## 8.6 Organizations Comments and Responses

### **First Letter of Objection to Monterey Peninsula Water Supply Project (MPWSP) CalAm's defective and incomplete draft EIR/EIS**

Figure 2. Slant Well Patent, 2011,<sup>32</sup> showing the inflow directly above the submersible pump. The presented upside down bell curve (red arrow), is the anticipated pumping profile through the sea floor. More elaboration about induced infiltration can be found in Williams 2015.<sup>33</sup>

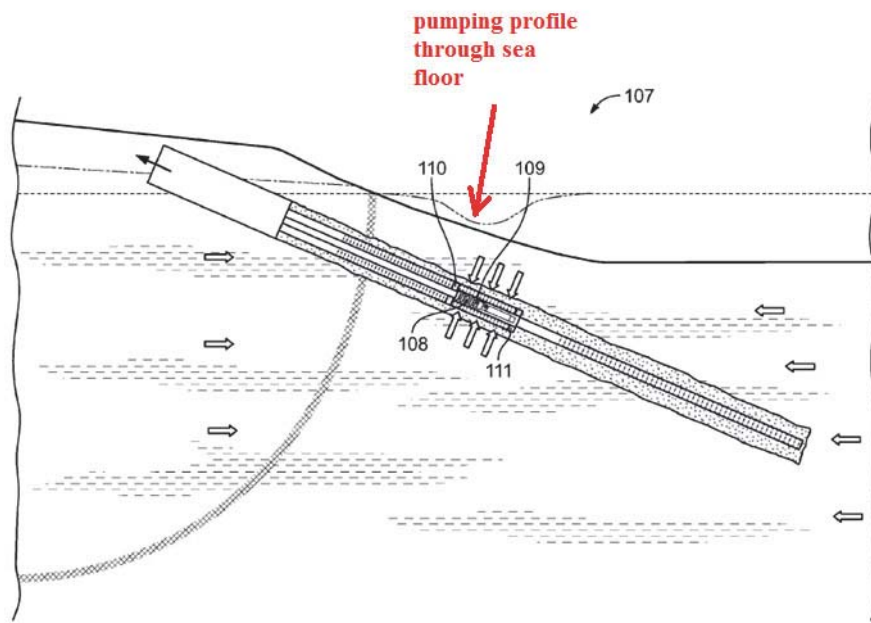
CURE-Sobczynski-1 cont.

**Figure 3. Qualitative illustration of pressure gradient present at pumping speed of  $0.132\text{m}^3/\text{s}$  by the submersible pump. Position of submersible pump is at  $x=-70\text{m}$ , and  $y=-19\text{m}$**

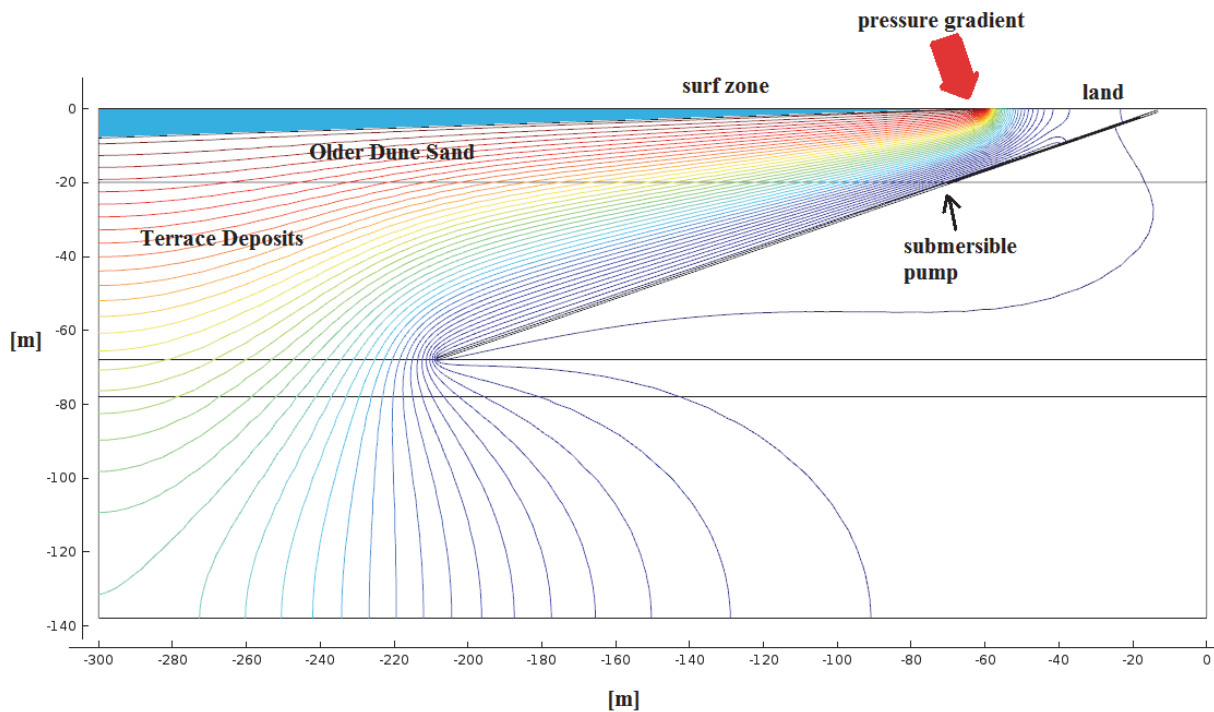
CURE-  
Sobczynski-1  
cont.

**Figure 4. Geological cross section through the project site. The drawings aspect ratio has not been preserved.<sup>36</sup>**

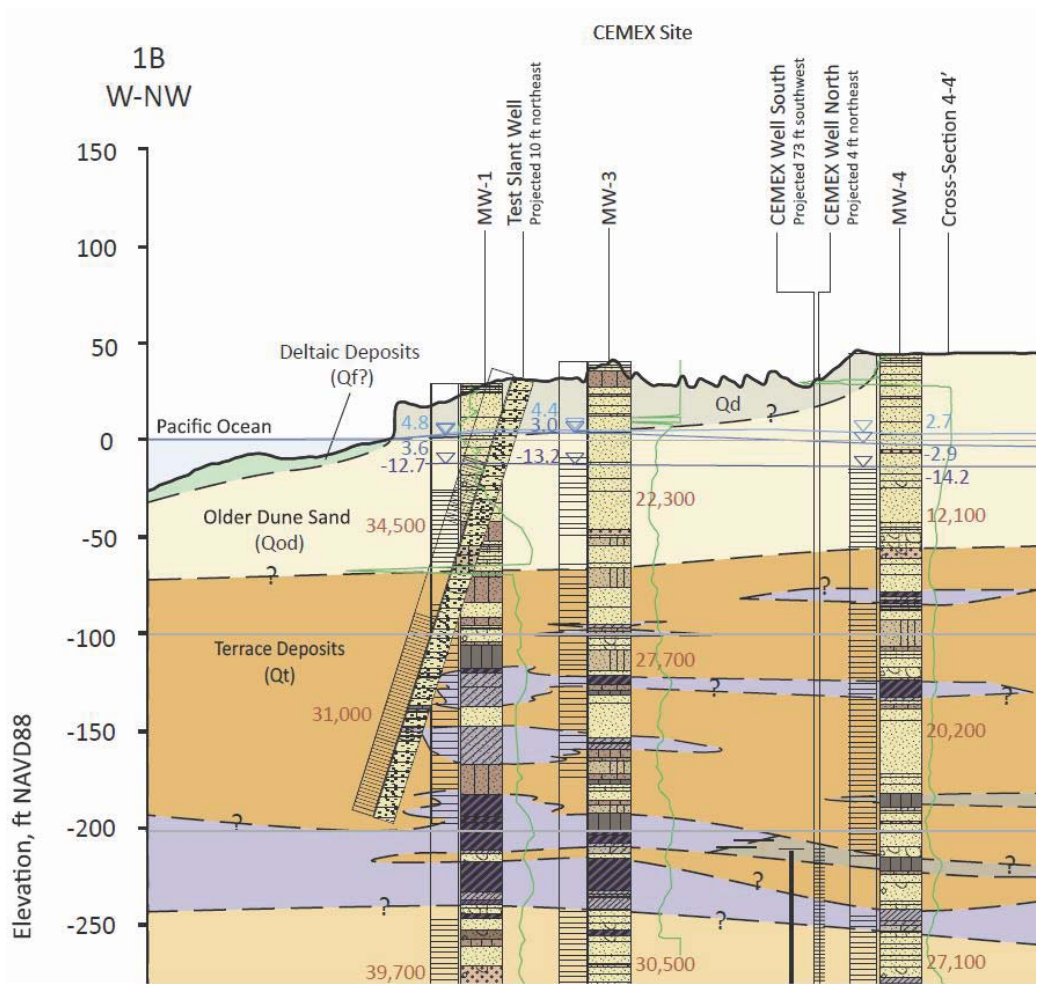
Note, however, that this picture does not preserve the actual angle the test slant well was designed to operate at. When accounting for the approximate 19 degree angle, the picture of the slant well becomes clearer.

205335.01 Monterey Peninsula Water Supply Project  
Figure 3-3a  
MPWSP Seawater Intake System

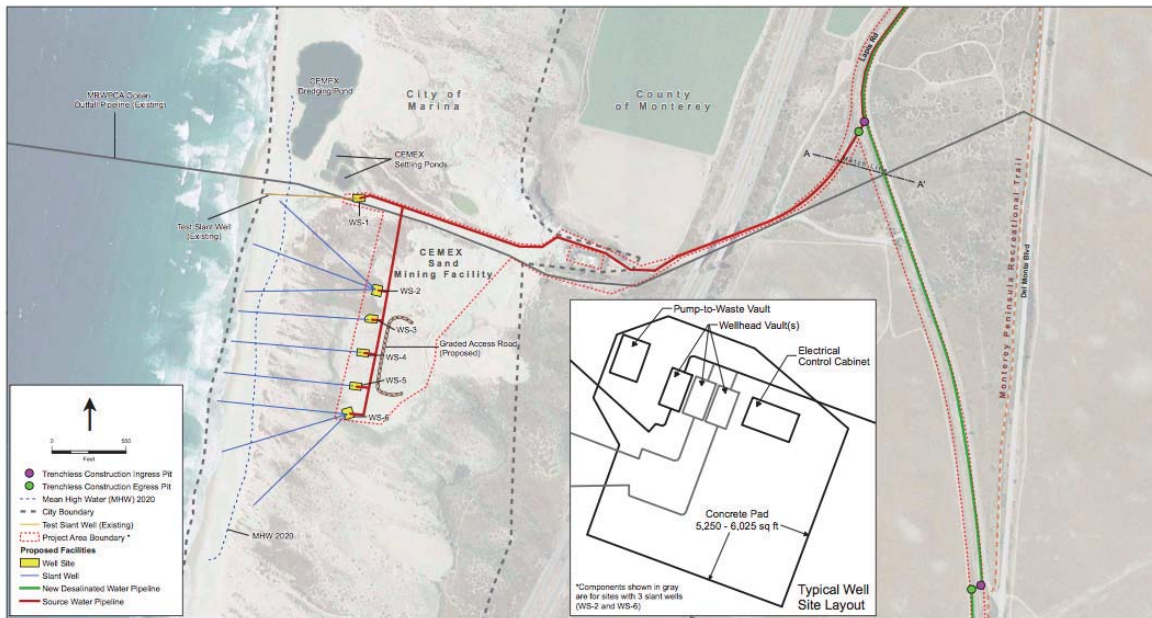
| Comment # | Section Name                   | Page #     | Paragraph or Table #                 | Issue                                                                                                                                                                               | Suggested Resolution                                                                                                                                                                                                                                                                                                                                                                                                                                                                                                                                                                                                                                             |          |
|-----------|--------------------------------|------------|--------------------------------------|-------------------------------------------------------------------------------------------------------------------------------------------------------------------------------------|------------------------------------------------------------------------------------------------------------------------------------------------------------------------------------------------------------------------------------------------------------------------------------------------------------------------------------------------------------------------------------------------------------------------------------------------------------------------------------------------------------------------------------------------------------------------------------------------------------------------------------------------------------------|----------|
| 25.       | 3.2.1 Seawater Intake System   | 3-13       | Figure 3-3a                          | We believe some minor corrections to this Figure are necessary to show the current slant well layout.                                                                               | See redlined figures provided.<br>Please see Attachment A to this chart for corrections to this Figure.                                                                                                                                                                                                                                                                                                                                                                                                                                                                                                                                                          | CalAm-25 |
| 26.       | 3.2.1 Seawater Intake          | 3-13       | Figure 3-3a                          | Sizing and specific project components require minor clarifications in this Figure.                                                                                                 | We request the following additional minor clarifications to the Figure:                                                                                                                                                                                                                                                                                                                                                                                                                                                                                                                                                                                          |          |

| Q33<br>3-13 | Figure 3-3a MPWSP Seawater Intake System                                                                                                                                                                            | Figure 3-3a clearly shows the plan for well locations. By simple observation, intake screens are landward. This surely did not escape the attention of the consultants. The DEIR has not explained intake screen locations. This is a major omission.                                                                                                                                                                                                                                                                                                                                                                                                                                                                                                                                                                                                                                                                                                                                                                                                                                                                                                      | PWN2-33          |

- CalAm-25 Figure 3-3a has been revised to make the clarifications described in the comment.
- CalAm-26 The requested clarification has been made.
- CalAm-27 Figure 3-3b has been revised to make the clarifications described in the comment.

205335.01 Monterey Peninsula Water Supply Project  
Figure 3-3b  
Illustrative Cross-Sectional View of Subsurface Slant Wells

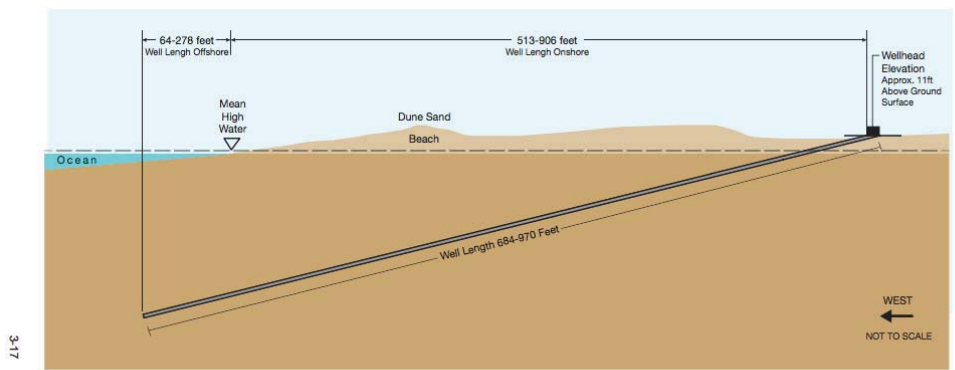
| Comment # | Section Name                   | Page # | Paragraph or Table # | Issue                                                                                                                                                                                                                                                                                                                                                                                                                                                                     | Suggested Resolution                                                                                                                                                                                                                                                                                                                                                                                                                                                                                                                                                                                                                                                                                                                                                                                                                                                                                                                                  |
|-----------|--------------------------------|--------|----------------------|---------------------------------------------------------------------------------------------------------------------------------------------------------------------------------------------------------------------------------------------------------------------------------------------------------------------------------------------------------------------------------------------------------------------------------------------------------------------------|-------------------------------------------------------------------------------------------------------------------------------------------------------------------------------------------------------------------------------------------------------------------------------------------------------------------------------------------------------------------------------------------------------------------------------------------------------------------------------------------------------------------------------------------------------------------------------------------------------------------------------------------------------------------------------------------------------------------------------------------------------------------------------------------------------------------------------------------------------------------------------------------------------------------------------------------------------|
| 28.       | 3.2.1.1 Subsurface Slant Wells | 3-17   | Figure 3-3b          | The lengths listed for onshore and offshore well lengths appear to require minor corrections. Please see table attached as Attachment C to this chart for values calculated by GEOSCIENCE (and refer to Attachment A – marked-up Figure 3-3a for well naming used for measurements/calculations). The updated well layout was used for the measurements. For comparison, lengths were calculated for current (2015) Mean High Water and the 2020 MHW used on Figure 3-3a. | The markups, from north to south, are:<br>SW-1<br>Stand-by-1<br>SW-2<br>SW-3<br>SW-4<br>SW-5<br>SW-6<br>SW-7<br>Stand-by-2<br>Stand-by-3                                                                                                                                                                                                                                                                                                                                                                                                                                                                                                                                                                                                                                                                                                                                                                                                              |
